PIONEER GLEN

MASTER DEVELOPEMENT PLAN

PIONEER GLEN
MASTER DEVELOPEMENT PLAN
SITE PLAN
CITY OF SAN ANTONIO
BEXAR COUNTY
TEXAS

Subject: **Master Development Plan Pioneer Glen, A/P #1009922**

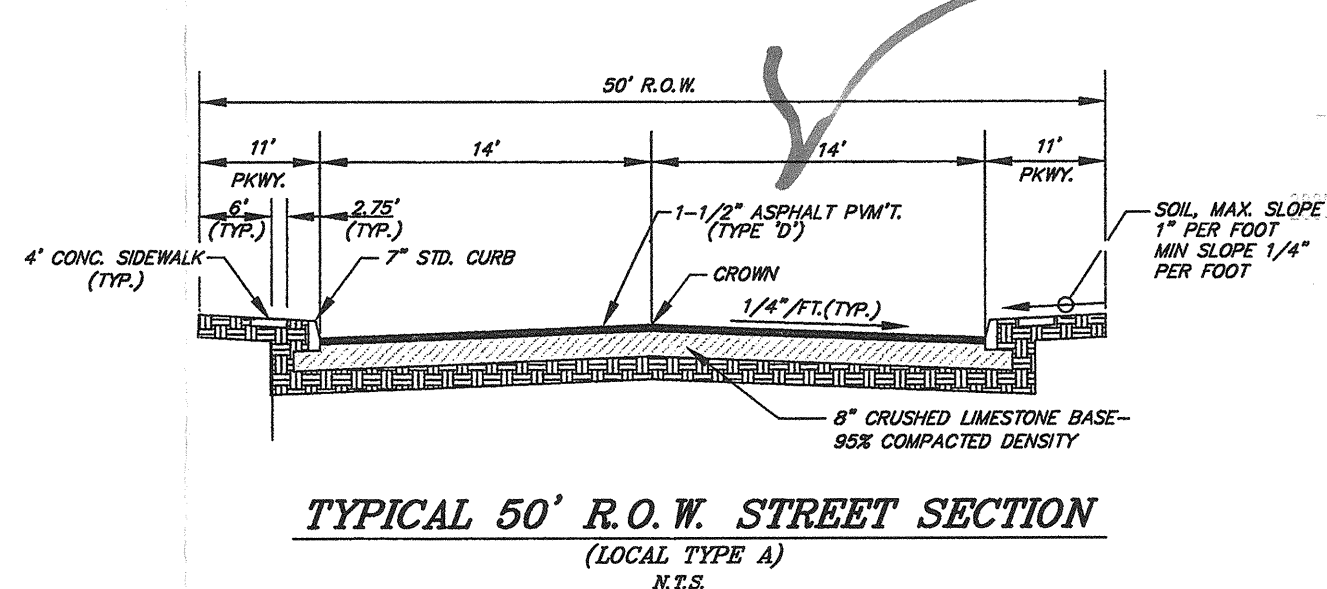
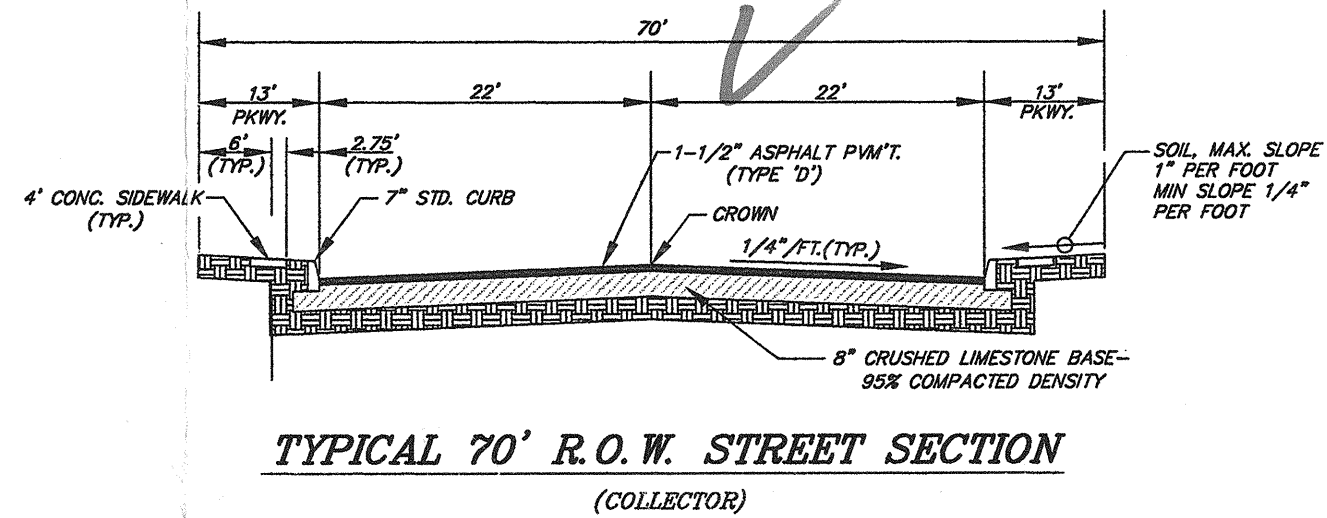
35-515(b)(3) BLOCK
Length - Review my TPA
local A's east of proposed thoroughfare

35-506(c) CLASSIFICATION
HIERARCHY OF PARKS
LOCAL A around my
TH to LOCAL B/
LOCAL B STREET west
of proposed thoroughfare

35-506(c)(2)
Preparation of Street to
the north

35:8101
LOCAL B AROUND
PARK AREA (PER TH.)
ANNOATE MISP Phase
ROADPLAIN LIMITS
ANNOATE ROW DM.
ON THOROUGHFARE
(PROPOSED RE-ALIGNMENT
OF NEAL RD. 120' ROW)
